HOPE BAY PROJECT

Proponent's Response to Technical Comments on the Madrid-Boston Final Environmental Impact Statement

April 2018

Figure1. Track lines of collared Dolphin and Union caribou in proximity to the Project and Hope Bay Belt infrastructure.

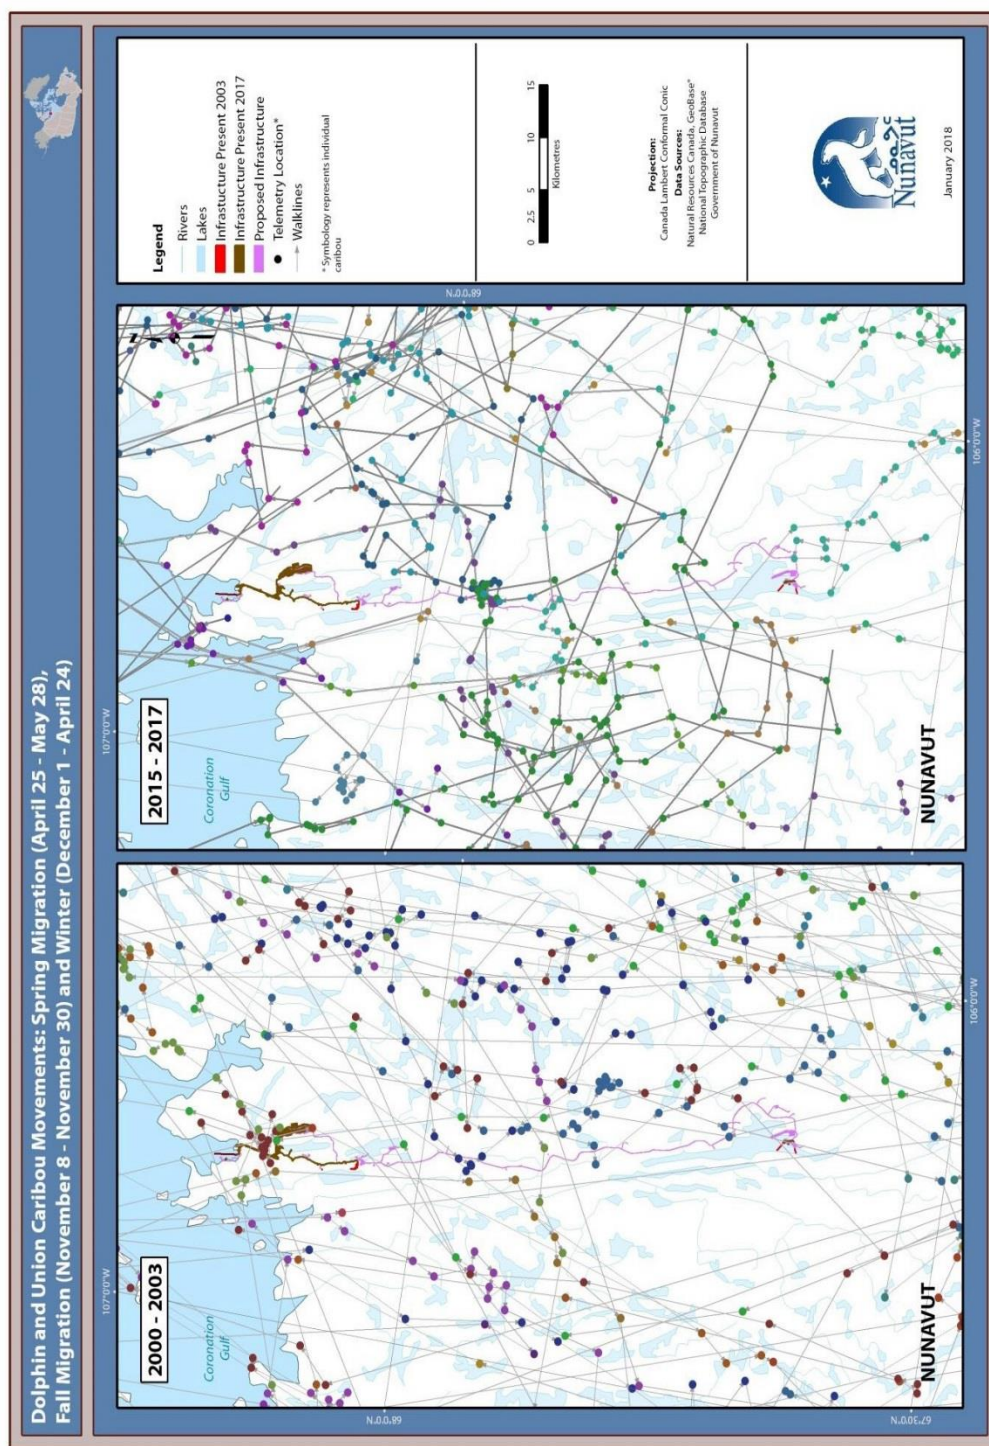
Figure 1 shows the movements of collared Dolphin and Union caribou during the seasons they are present around the Project (i.e. fall migration, winter, spring migration). These caribou cross the Doris to Boston road at numerous points along its length. In order for this mitigation strategy to be viable, crossings will have to be responsive to this data.

TYPICAL
ALL-WEATHER ROAD SECTIONS

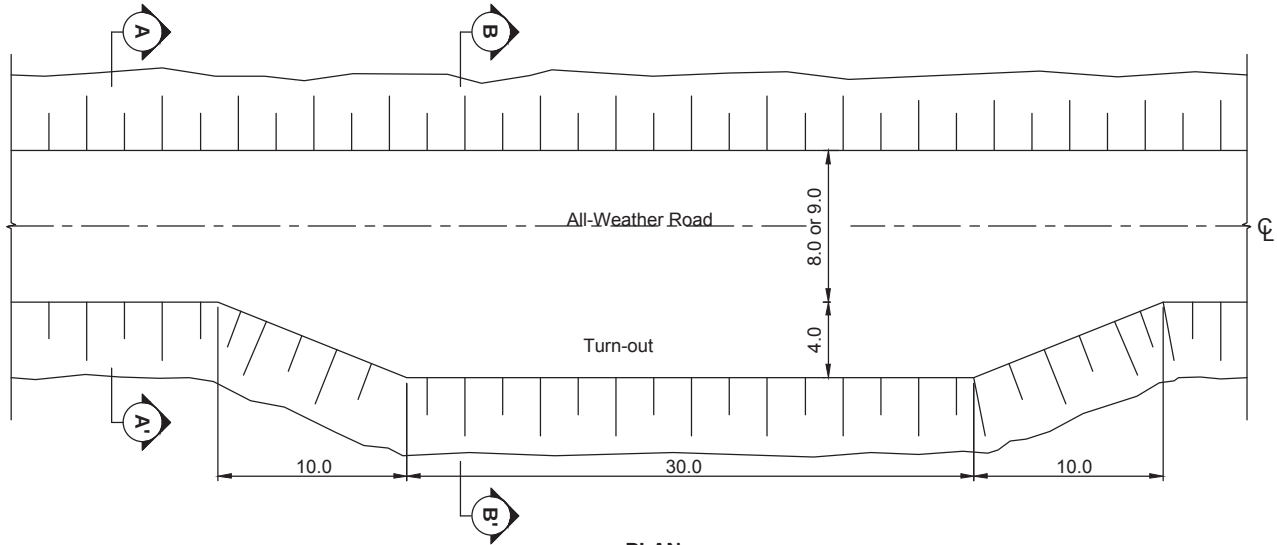
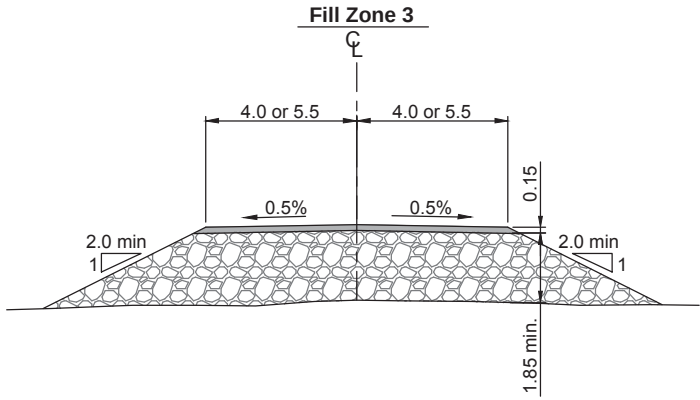
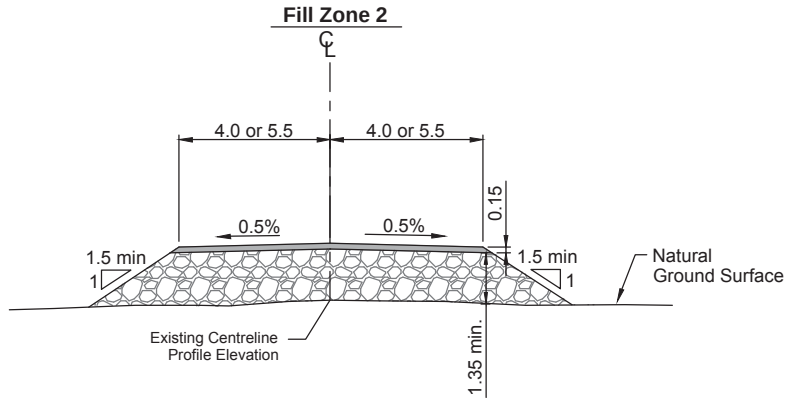
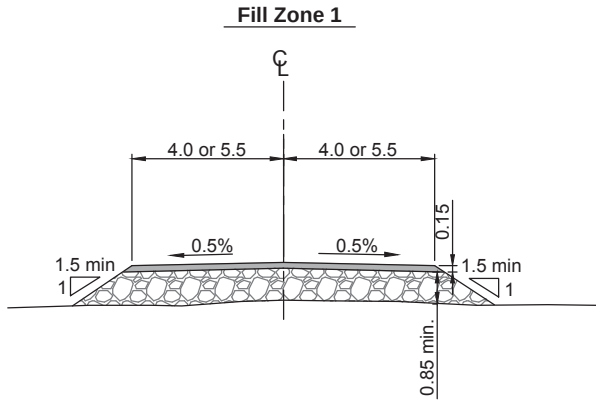
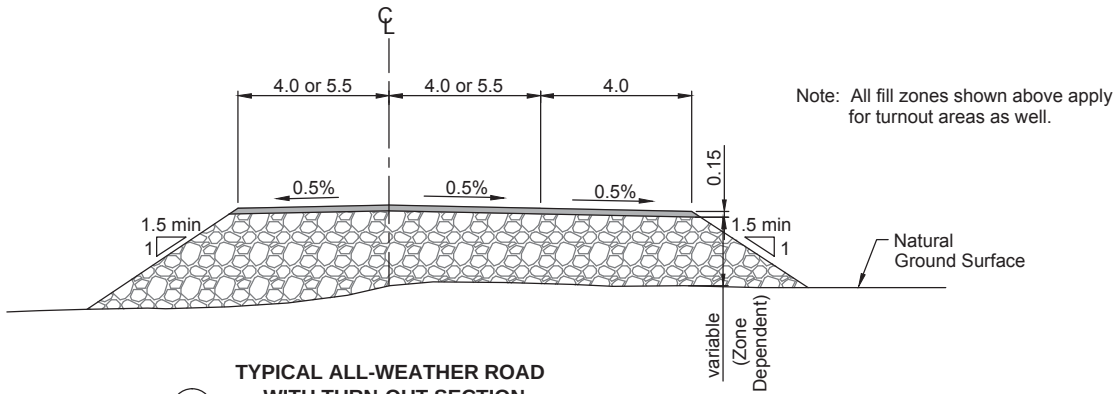
"The height of the remaining 99% of road surface is not predicted or estimated, including that along the 53 km Boston to Doris road (FEIS Vol. 3, s. 3.7.4.1). The extent to which Project roads will present a physical barrier or visual deterrent to caribou is therefore hard to assess."

Figure 1. Track lines of collared Dolphin and Union caribou in proximity to the Project and Hope Bay Belt infrastructure.

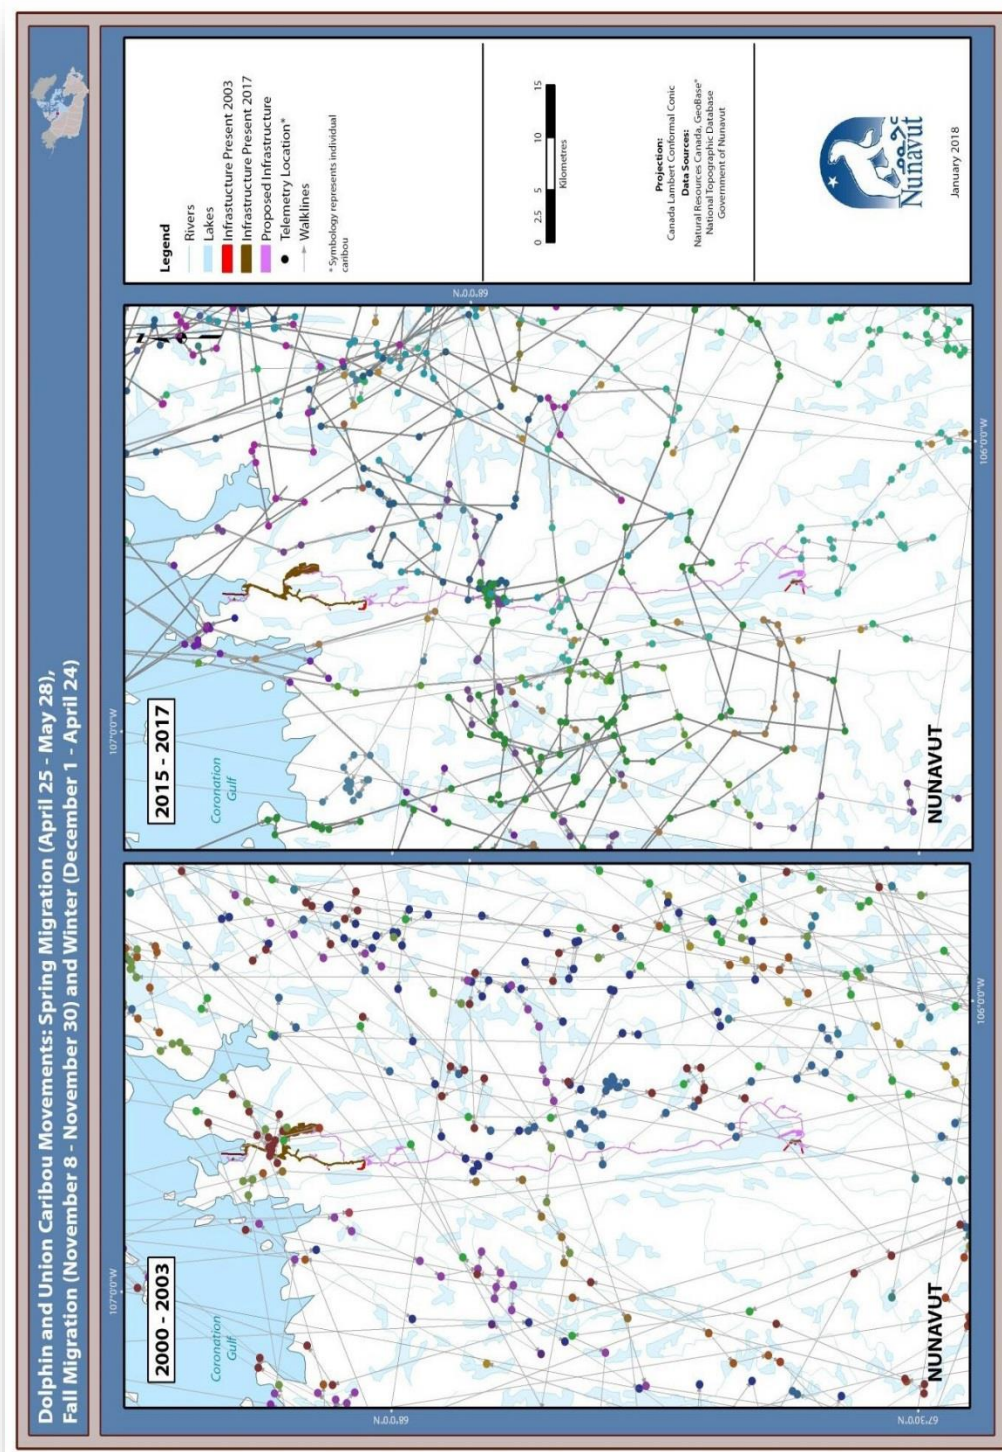
Figure 1 suggests that herds are avoiding the Doris site. During review of the DEIS, the GN recommended that the Proponent analyze the available collar data to estimate the ZOI around the current Doris North mine. In the FEIS, the Proponent provides that there were insufficient collar data to support this type of analysis. The GN concurs with this finding and notes that there is need to obtain sufficient collar data to revisit this analysis if the Project proceeds.
